PRODUCT NEWS

Product Discontinuation Notices

May 15ᵗʰ 2023

Product Discontinuation	Recommended Replacement
Vision Sensors / Machine Vision System	Vision Sensors / Machine Vision System
STC-MBA5MUSB3	**STC-MBS500U3V**
STC-MCA5MUSB3	**STC-MCS500U3V**

[Dimensions]

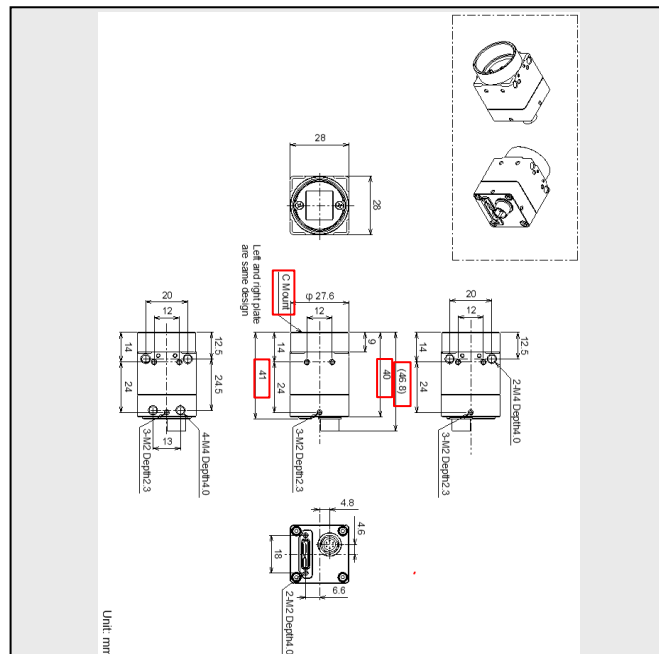
Product discontinuation Model STC-MxA5MUSB3	Recommendable replacement Model STC-MxS500U3V
Dimensions 28 (W) x 28 (H) x 33.8 (D) mm.	**Dimensions** The external dimensions are different. 28 (W) x 28 (H) x 40 (D) mm Lens mount is different.

[Wire connection]

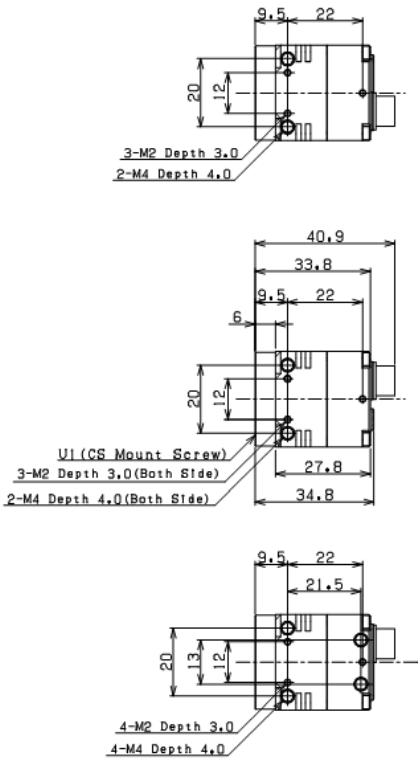
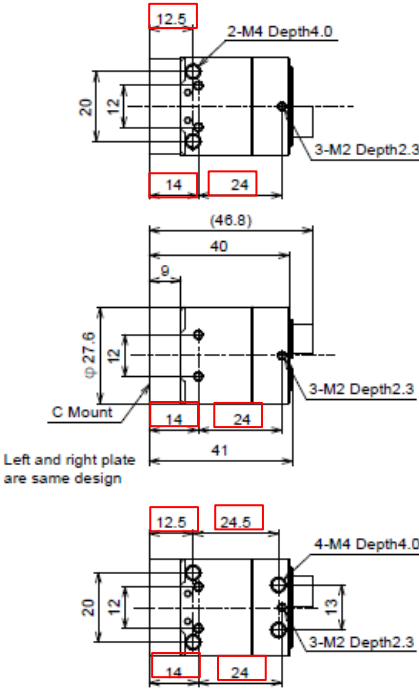
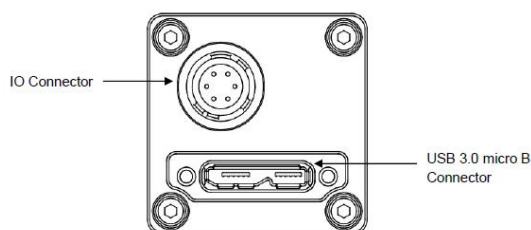
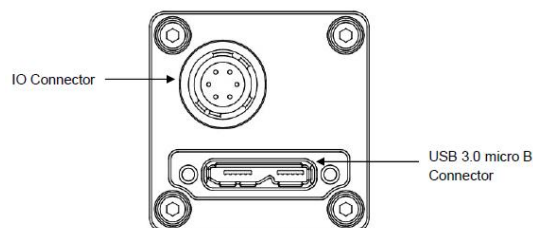
| Product discontinuation Model STC-MxA5MUSB3	Recommendable replacement Model STC-MxS500U3V
I/O Connector Two Inputs and Two Outputs	**I/O Connector** Three GPIOs, One Camera Hardware Reset The input/output voltages of the 2nd to 4th pins of the input/output signal connector are different. The signals of pin 5 and pin 6 are different.

[Mounting dimensions]

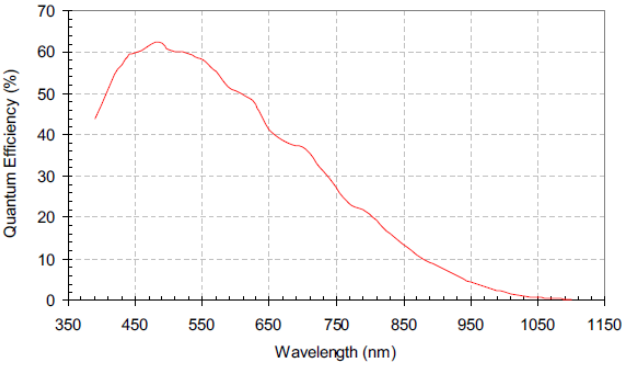
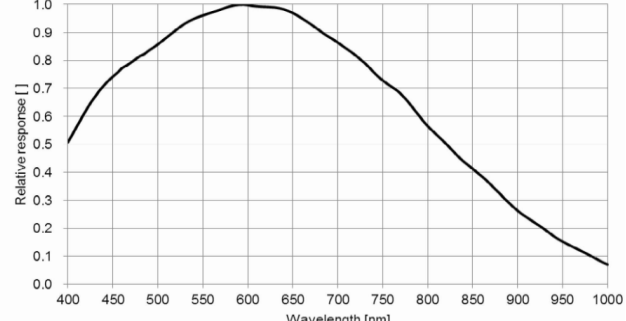
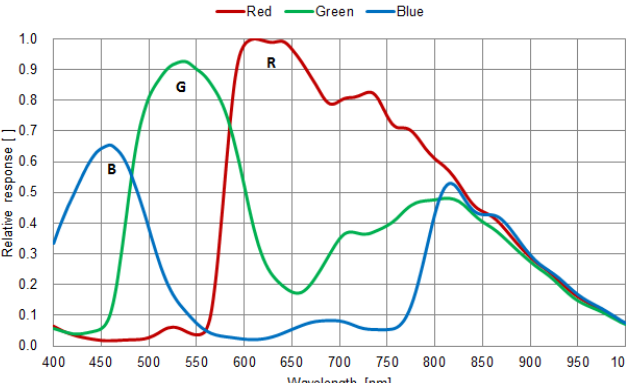
Product discontinuation Model STC-MxA5MUSB3	Recommendable replacement Model STC-MxS500U3V
Camera fixing screw position	**Camera fixing screw position** The positions of the screw holes are different.
